Responsiveness Summary

Lower Fox River and Green Bay, Wisconsin Site Record of Decision, Operable Units 1 and 2

December 2002

Figure 1 Carp PCB Tissue Concentrations in OU 1

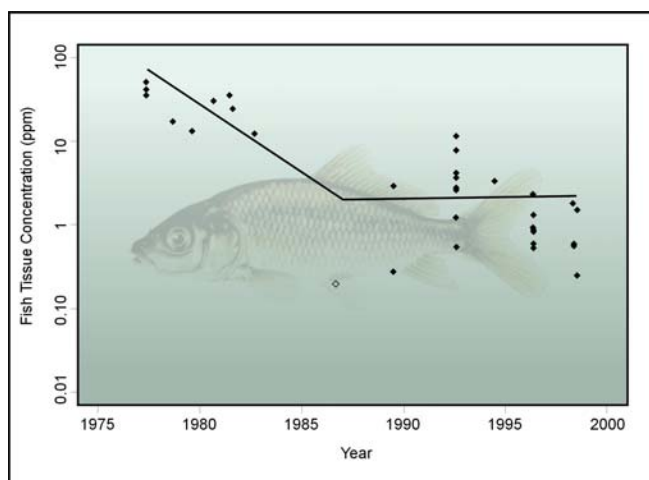
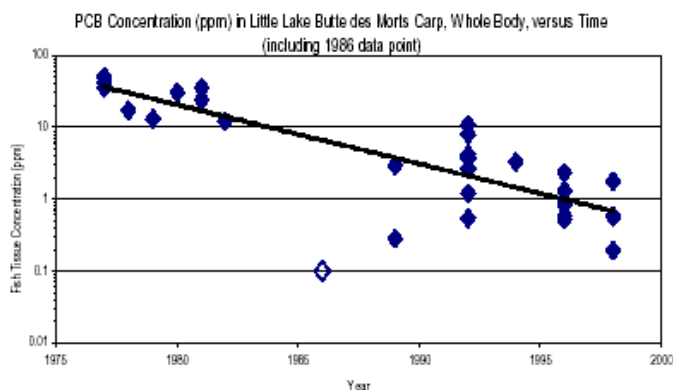
The commenters contend that PCB concentrations in fish tissue are continuing to show decline within the Lower Fox River. They dispute the statistical

WDNR and EPA believe that fish tissue concentrations have not continued in a downward trend at the rate suggested by the commenters. Furthermore, the analysis conducted for the RI/FS suggests that in many cases, the rate of change has slowed to unacceptably slow levels, or in some cases stabilized and show no change at all.

The central dispute raised by these comments can be seen in the differing interpretation of changes in fish tissue concentrations in the two graphics below. Figure 1, from the Proposed Plan, shows that carp PCB tissue concentrations in OU 1 decline up to a point where a statistically significant “breakpoint” is observed, and that the change in the rate of decline from that point in time is essentially flat. As presented in the TTA, the breakpoint for that species in that reach of the River appears to occur around the mid-1980s. Figure 2 shows the direct-line comparison, using the same data, presented by the FRG’s consultant, BBL, which suggests a steady state and continuing decline. This was also observed for several other species in OUs 1 and 4.

The TTA presented an analysis of trends in PCB concentrations for fish throughout the River and southern Green Bay. The analysis demonstrated that the rate of decline in fish tissue concentrations observed through the 1970s changed. Several important fish species, including carp, perch, and walleye, show statistically significant slowing of the decline rate, with a breakpoint occurring in the trend in the early to mid-1980s. Even where decline was noted, WDNR and EPA believe that the fish tissue concentrations will remain at concentrations above acceptable levels for some time to come.

Figure 3 Total PCB Discharges in OU 1 from 1972 to 1997

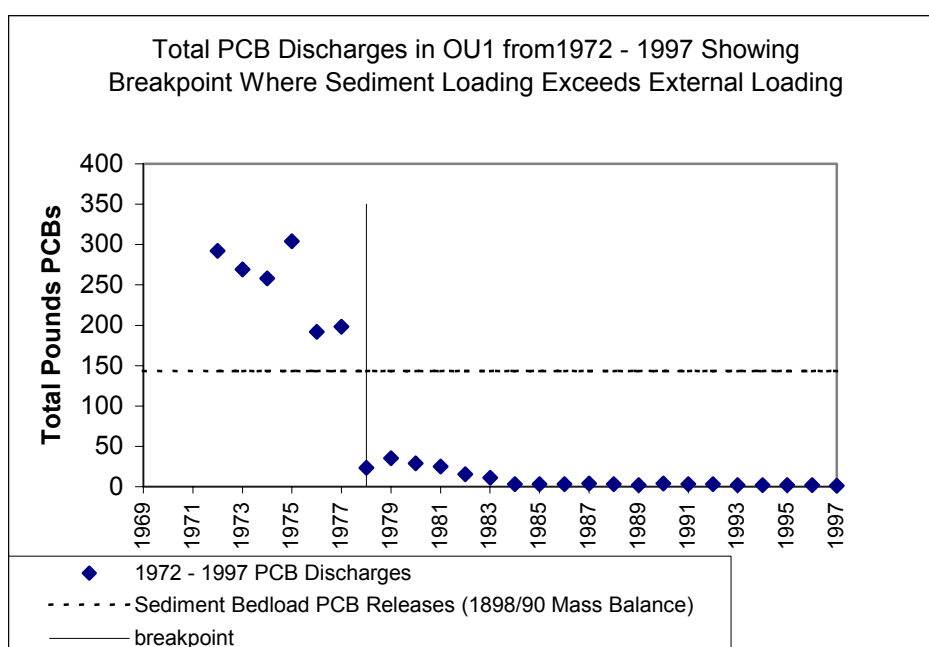
Commenters took issue with the comprehensive time trends analysis conducted for the RI. They argue that there are declines in PCB concentrations in fish tissue, sediments, and water that are not used or improperly applied in the RI/FS and Proposed Plan. Their analysis is based on two papers submitted: *BB&L Report on PCB Trends in Fish from the Lower Fox River* (the “BBL Report”) and *Time Trends in PCB Concentrations in Sediment and Fish, Lower Fox River, Wisconsin* by Dr. Paul Switzer.

Figure 3 represents this graphically for the period of 1972 to 1997 in OU 1. Prior to 1978, direct discharge releases still exceeded those PCB loads documented by the 1989/1990 Mass Balance Study, which is shown as the hatched line at 143 pounds annually. In fact, the exposure concentrations seen by fish in OU 1 prior to 1978 would have been a combination of both the direct and sediment PCBs. This trend is typical of the entire River, although the data in TM2d suggest that greater direct loads were still contributed into OU 4 into the mid-1980s.

This above does not, however, necessarily imply that the break will occur exactly in 1978, and in fact, most of the breakpoints shown in the TTA come in the early to mid-1980s. The TTA acknowledges that the breakpoints are “best fit” models, and are not precise estimates of the year in which change occurs. In the case of the carp example shown above for OU 1, there are very few data points for concentrations between 1982 and 1986. Equally important in evaluating the breakpoint is the biology of the fish themselves; fish exposed in the late 1970s will continue to be present in later years. For example, the usual longevity of carp is 9 to 15 years (maximum observed is 47 years), while walleye average 7 years (Becker, 1983). Thus, carp exposed in 1971 when as much as 28,000 pounds of PCBs were discharged into the River would still be in the system in the mid-1980s.

Figure 4 Water Column PCB Half-Life

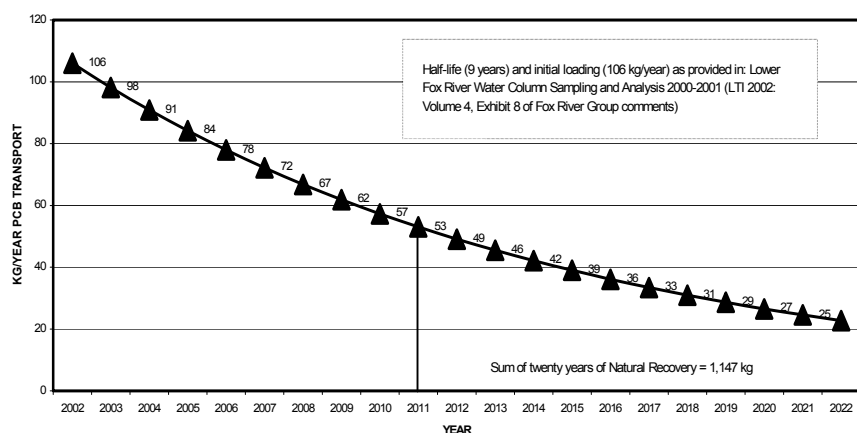
SMU 56/57 (USGS, 2000). Based on these results, where the commenter acknowledged that this set of data represents the most comprehensive data set available, the PCB loss approximated 2.2 percent of the mass removed. Applying the loss rates from this project that removed the most highly contaminated sediment in the entire Lower Fox River to the proposed remediation would equate to a total loss of 644 kg of PCBs. The commenter supplied a PCB decline rate, which the Agencies believe is incorrect. However, even applying this rate of decline at face value, over the next 20 years, almost 40 percent less PCBs mass would be transported to Green Bay during active remediation (650 kg) than by the no action alternative (1,140 kg). Similarly, the target removal of 1,700 kg of PCBs from Little Lake Butte des Morts would potentially release less than 40 kg of PCBs, roughly only twice as much as one responsible party suggested is contributed annually to the loading leaving Little Lake Butte des Morts.

Relative to PCB concentrations, data collected during high-flow events or ship movements within the River have clearly shown that these actions can result in concentrations equal to concentrations found during dredging.
